PGP Steering Committee Meeting
November 12, 2020 9:30 am
ZOOM

Protected Bike Lane Considerations and Vermont/ San Bruno Intersections

17th Street Streetscape Plan

POTRERO GATEWAY
STREETSCAPE IMPROVEMENTS

PAVING PLAN VERMONT STREET 17TH ST TO MARIPOSA ST

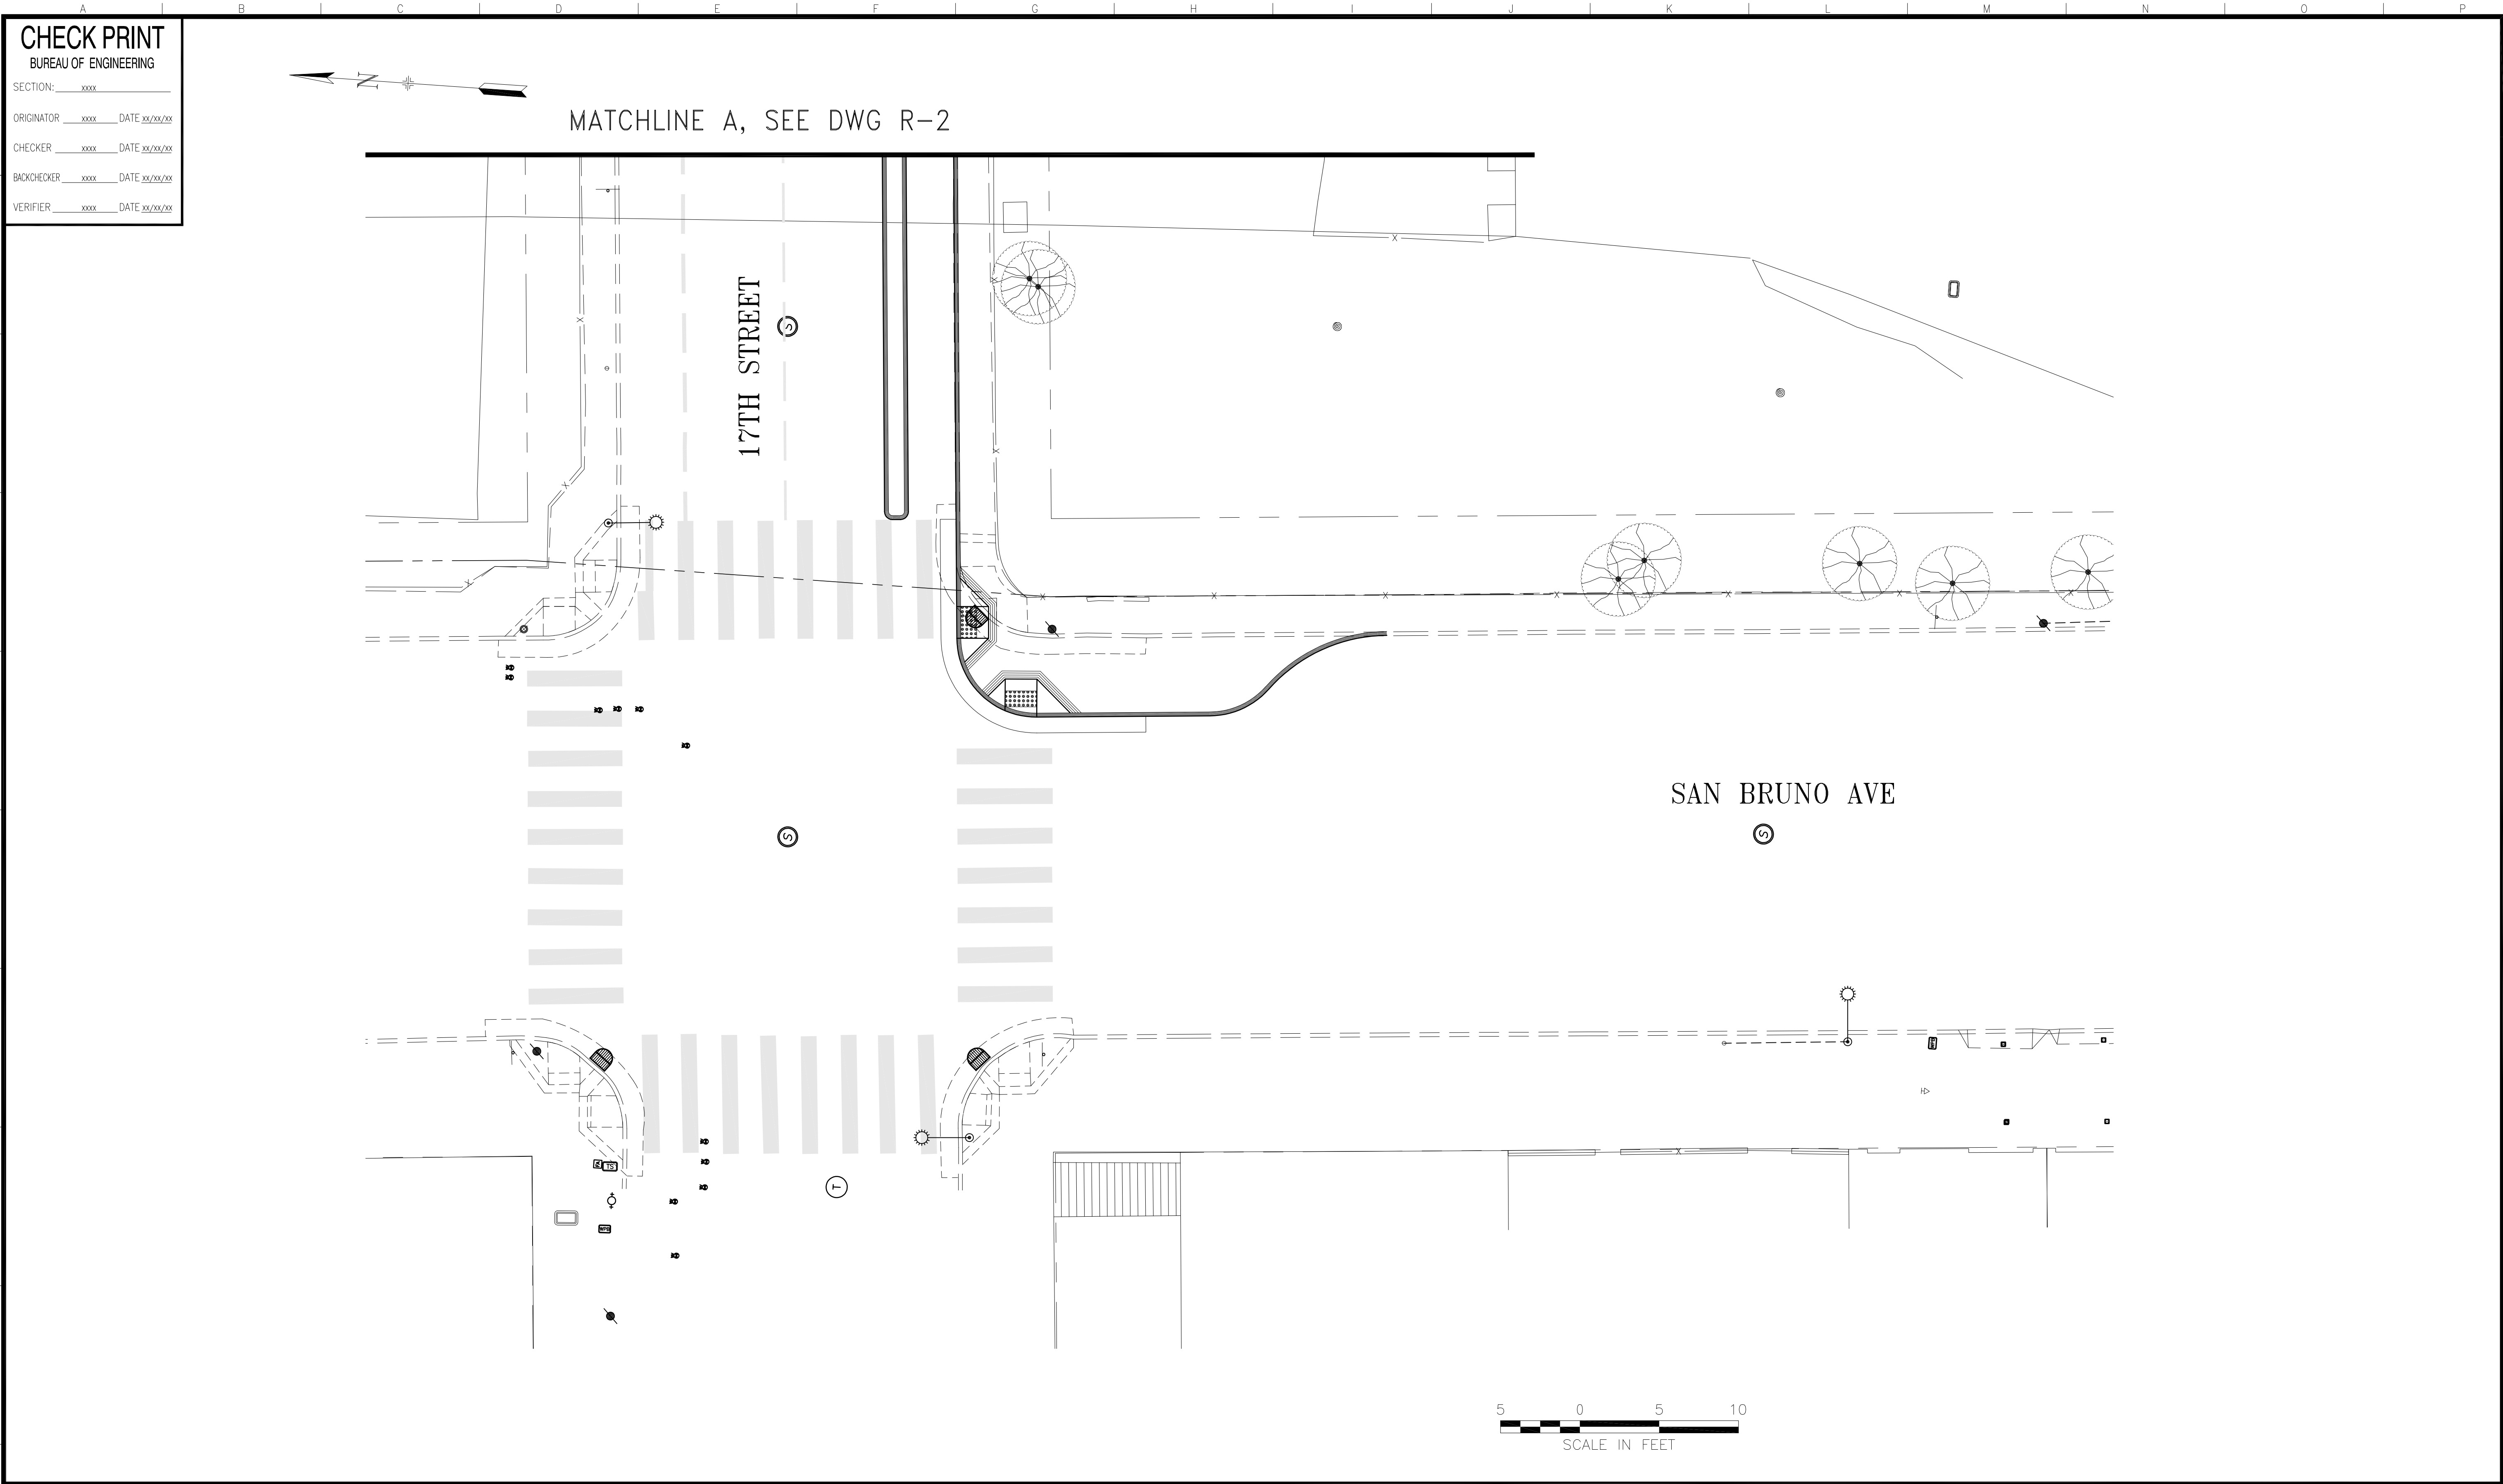
3. Plan: Mixing zones
 - Corner Wedge at 17th and Vermont NE corner
 - Will consider but disinclined because 1) low accident rate, 2) new idea, design not tried, 3) delivery truck turning radius

- MTA should Make parking on 300 block Vermont perpendicular.
 - Move EW North crosswalk north was suggested but not agreed to
 - Other Features? Mike will continue thinking about this

4. Plan: Don't make the SW corner -17th/ Vermont taper - make bike lane 7 ft all the way through
5. Plan: Don't taper the NW corner -17th/ Vermont median - use green paint

6. Plan: Review with the Fire Dept, good that there are no buildings
7. Plan: Bike lane size - 7ft is good
8. Plan: Median width - 2 ft is good
9. Note: that the autoshop on Vermont NE corner has a curb cut in the mixing zone. That is a reason for more protection

10. Cars exiting Vermont going left towards Potrero often think Vermont is a One Way Street.
11. Plan: Solution is a double yellow line from Vermont to Potrero

Mixing Zone heading west on 17th before Vermont poses a problem because of the Auto Shop driveway

PAVING PLAN
SAN BRUNO AVENUE
AT 17TH STREET

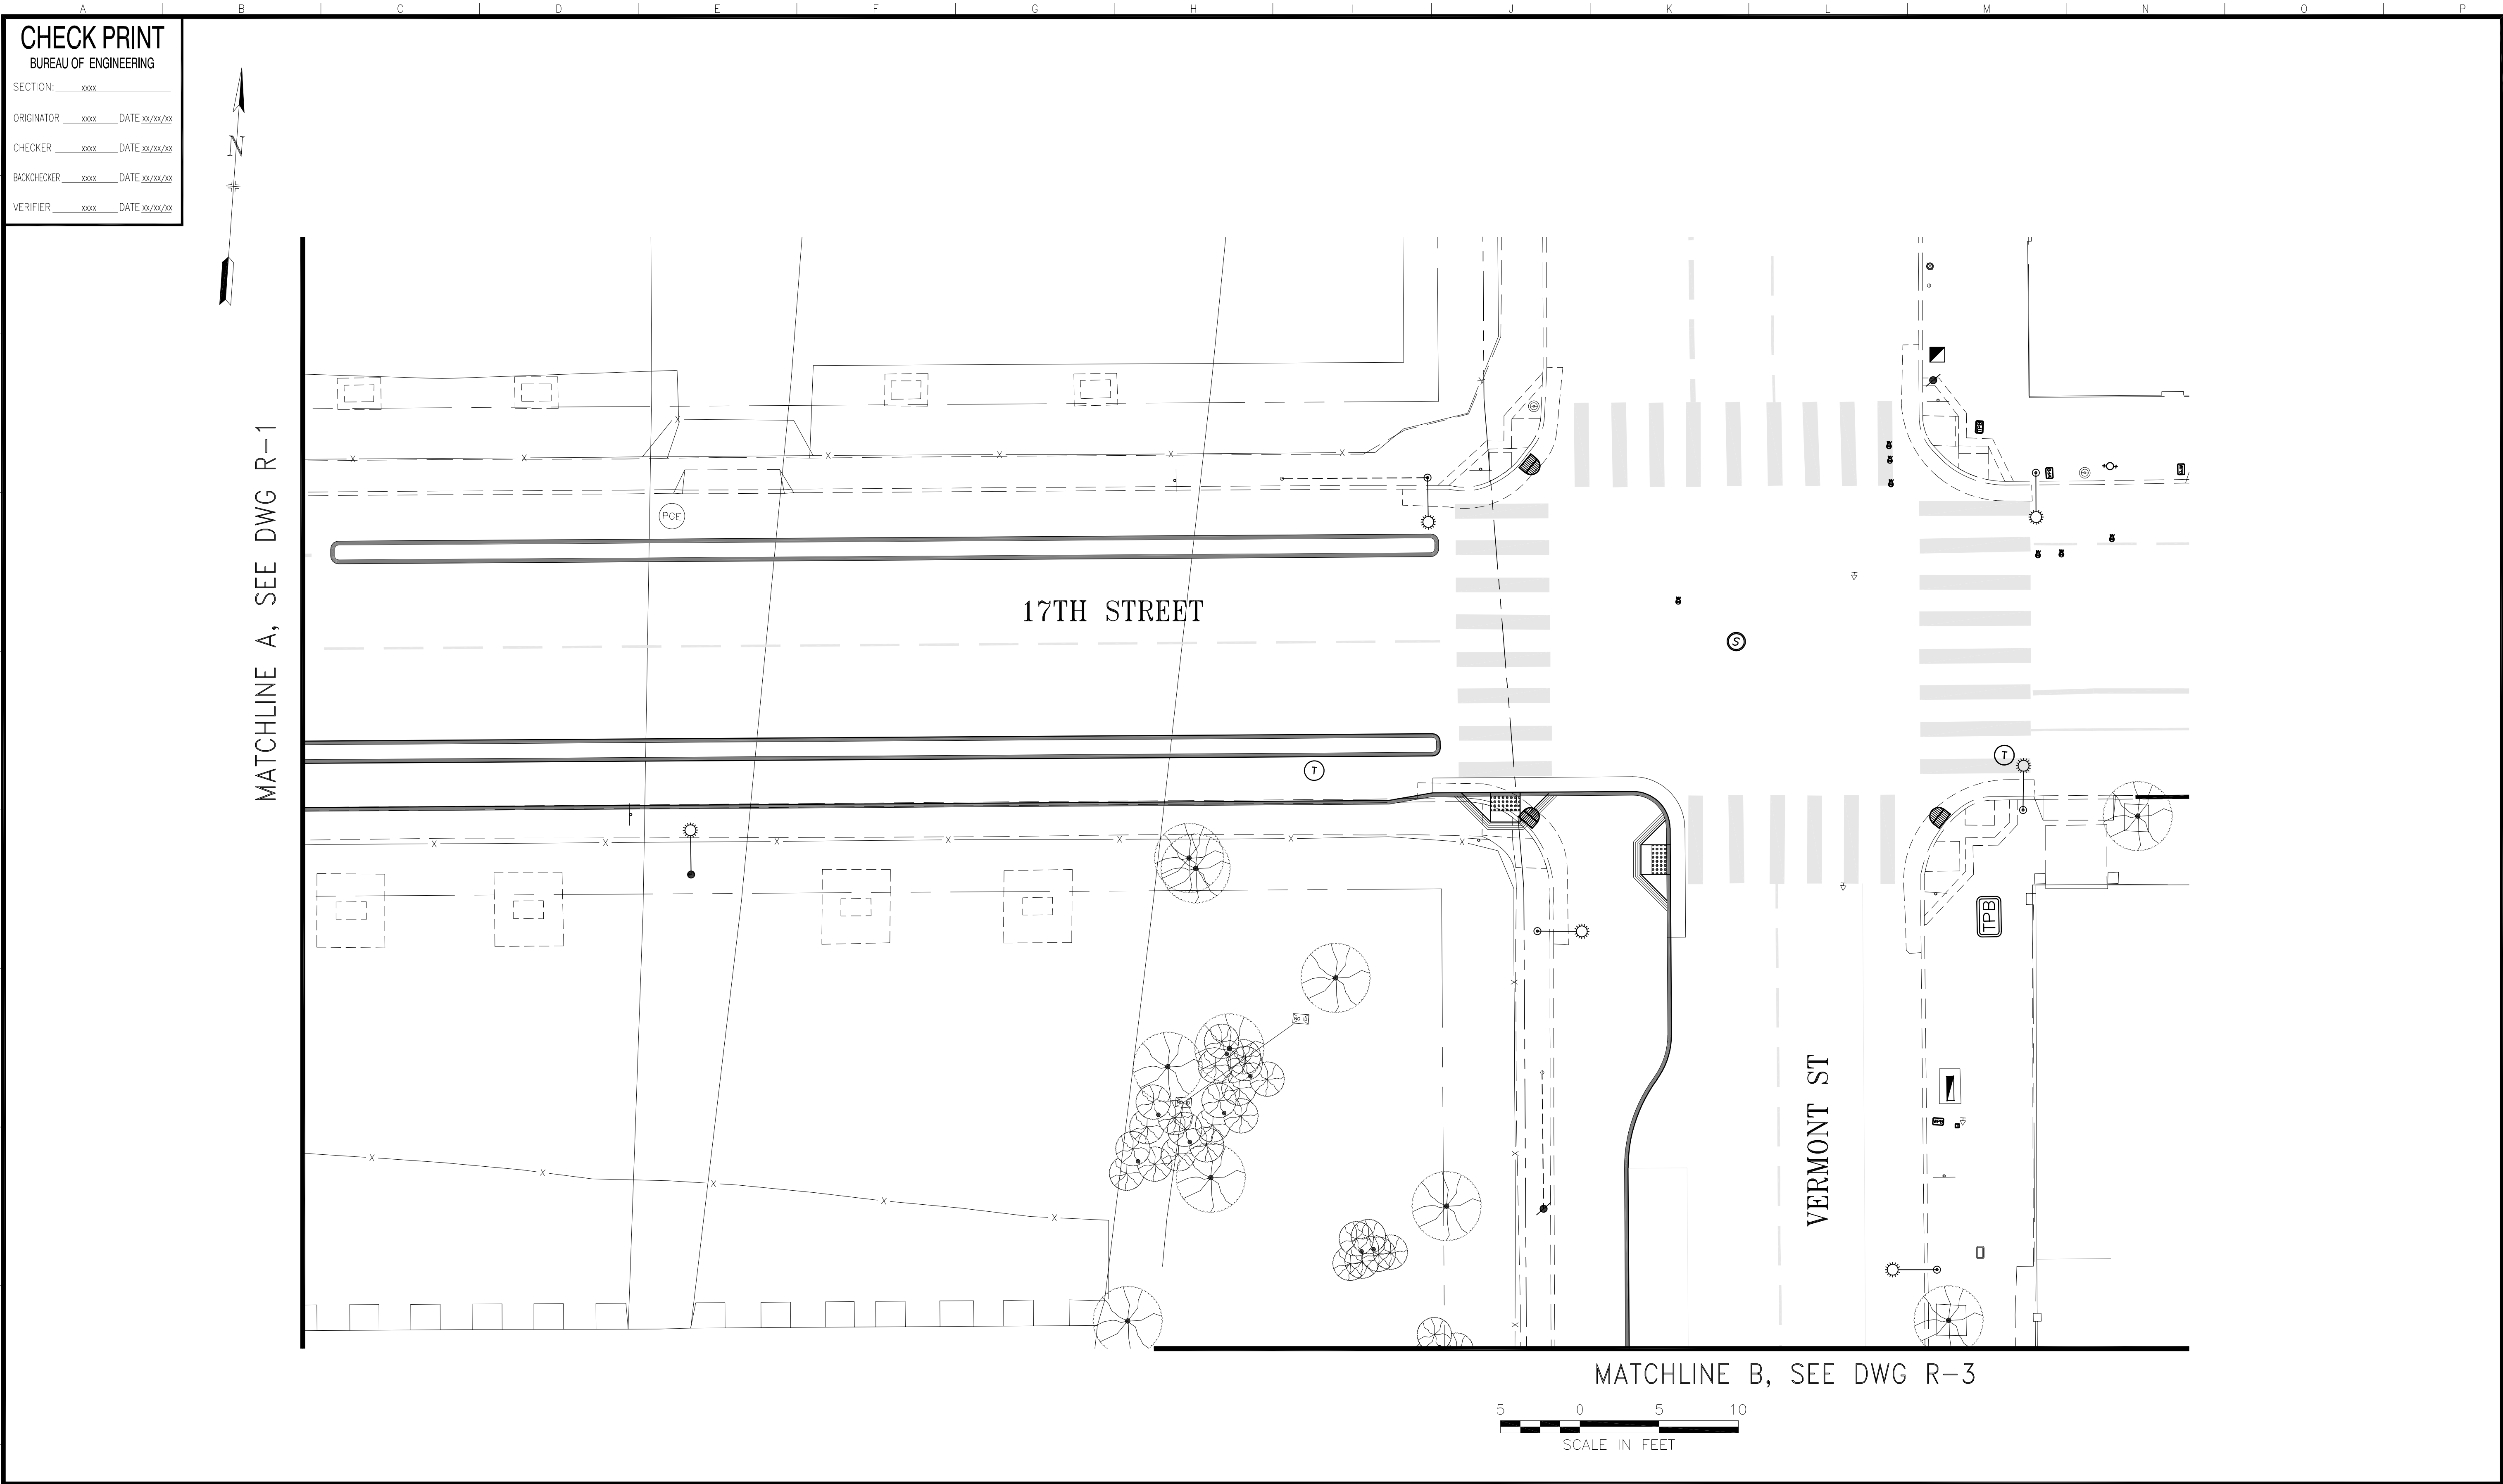
12. Note: San Bruno 17th Intersection doesn't have many accidents.
13. Note: Median on Vermont affecting the left turn from Vermont should be considered
